**North Coast Regional Water Quality Control Board**

Date: February 7, 2013

Subject: Water Quality focused Pre-Harvest Inspection Report for THP 1-12-114 HUM,  
Mad River.

**Nacho Libre THP** Section 6, T5N, R3E, HBM **THP Map** USGS 7.5' Quadrangle: Korbel (1979) Scale: 1 inch = 750 feet  
 Contour interval = 40 ft.

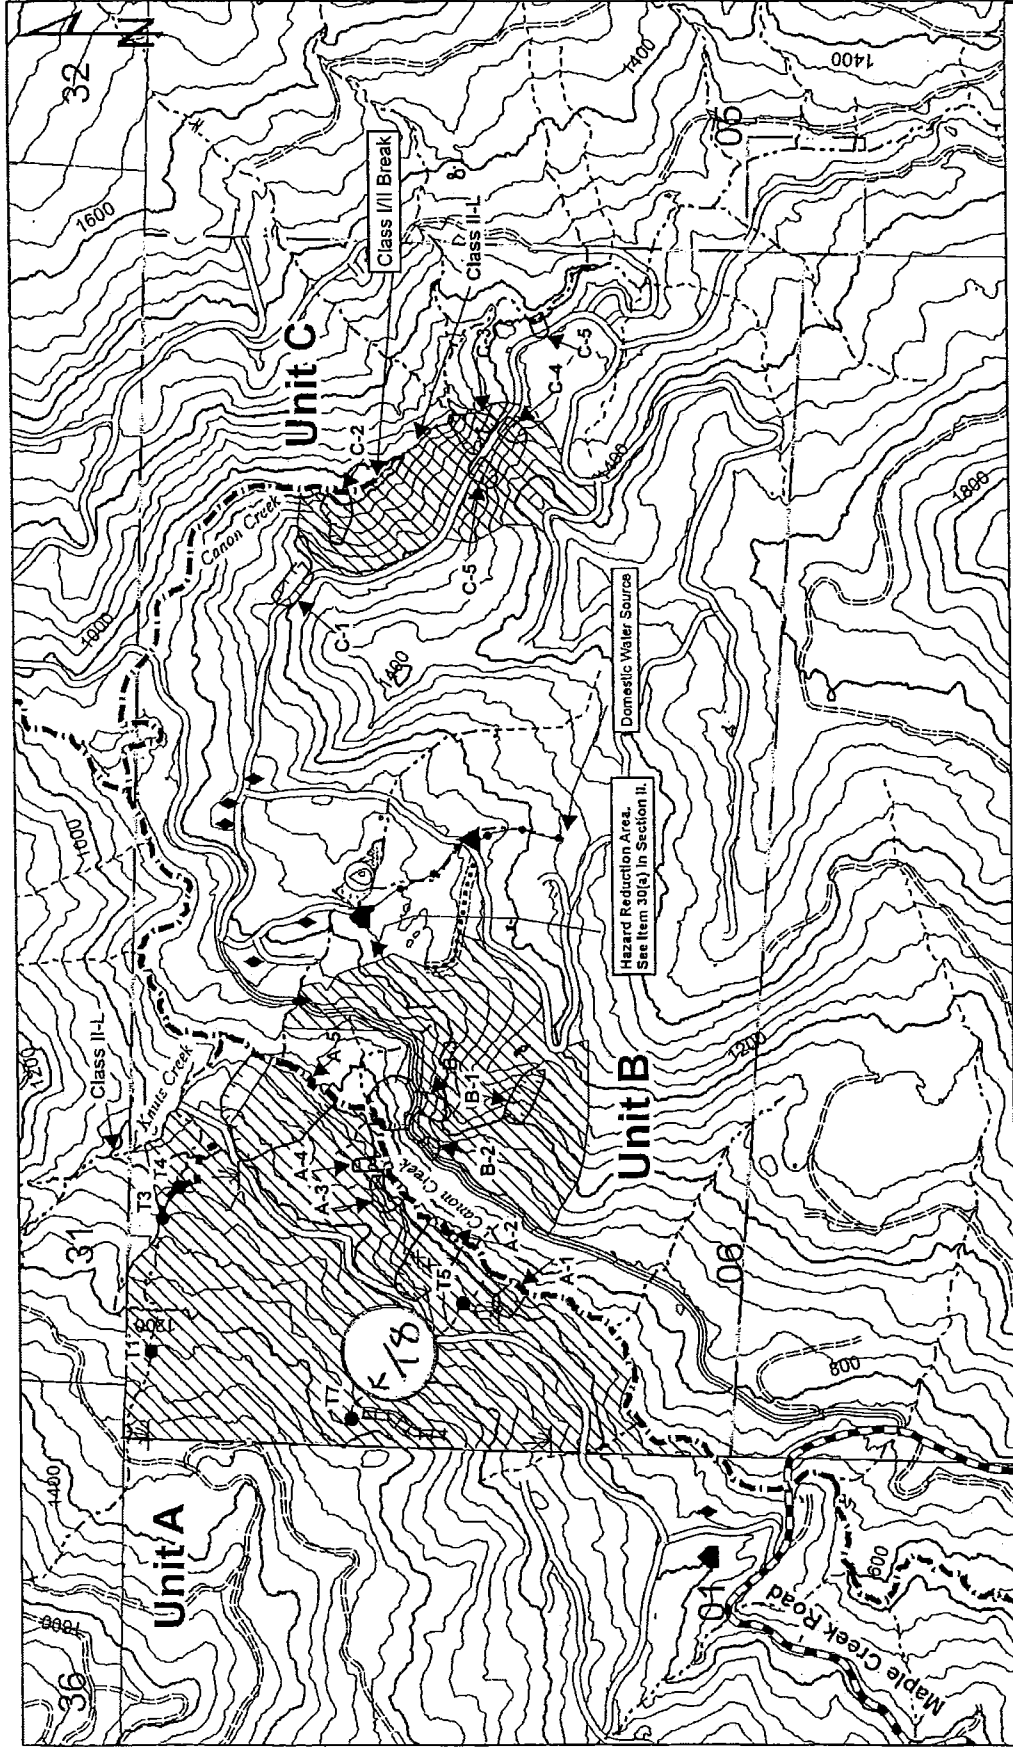
The primary purpose of the focused PHI was to address potential impacts in Unit A from the proposed oversized clearcut, and concentrated on the road system and the proposed watercourse protection measures for Unit A. The main road system in the plan area is in good to fair condition. Point T8 is a new road point that was identified during the focused PHI. There is a C III watercourse that flows across an old skid trail at Point T8 before reentering the original watercourse channel. To ensure that the watercourse does not get diverted down the skid trail, we agreed in the field that Point T8 will be added to the Road Work Order with language that ensures an enhanced berm is constructed **(Rec. 1)**.

There is a C III watercourse segment with a highly eroded channel approximately 25 feet upslope of Point T3. The eroded watercourse channel continues downslope to Point T5. In an effort to minimize the risk of additional channel bank erosion, the inspection team agreed to establish a 15 foot no harvest buffer for this watercourse segment, with the exception of a few trees that were marked for harvest at the time of the inspection **(Rec. 2)**.

The THP proposes the reconstruction of a skid trail in Unit A that crosses an unstable area and would be adjacent to the WLPZ established for Canon Creek. Due to the elevated risk of soil discharge into Canon Creek if the skid trail was reconstructed across this area, the inspection team agreed in the field that the skid trail will not be rebuilt across the unstable area **(Rec. 3)**.

Another concern that was discussed during the focused PHI was the proposed winter operations. In an effort to minimize the risk of soil transport, the inspection team agreed in the field that winter operations be limited to felling only in Unit A **(Rec. 4)**.

It was noted that felling trees near C III watercourses during the winter period may occur. In an effort to minimize the risk of a potential discharge, the inspection team agreed in the

field that language be included in the THP that ensures equipment will be present near a C III watercourse in Unit A if there is the potential for a tree to fall into the watercourse during harvest operations in the winter period (**Rec. 5**).

Unit A contains large redwood C III channel zone trees. None of the trees observed were marked for harvest at the time of the PHI. 14CCR 916.9(e) (2) of the THP specifically states, "In all instances where trees are proposed to be felled within the channel zone, a base mark shall be placed below the cut line of the harvest trees within the zone. Such marking shall be completed by the RPF that prepared the plan, or a supervised designee, prior to the preharvest inspection". To ensure compliance with language in the THP, include language that specifies all channel zone trees in Unit A will be retained (**Rec. 6**).

1. Add Point T8 to the Road Work Order. Include language that ensures an enhanced berm is constructed so that the watercourse will not get diverted down the skid trail.
2. Establish a 15 foot no harvest buffer for the C III watercourse segment from approximately 25 feet upslope of Point 3 to Point T5, with the exception of a few trees that were marked for harvest at the time of the inspection.
3. Include language in the THP that ensures a skid trail will not be reconstructed across the unstable area in Unit A.
4. Include language in the THP that ensures winter operations will be limited to felling only for Unit A.

5. Include language in the THP that ensures equipment will be present in Unit A if there is the potential for a tree to fall into a C III watercourse during harvest operations.
6. Include language in the THP that specifies all channel zone trees in Unit A will be retained.
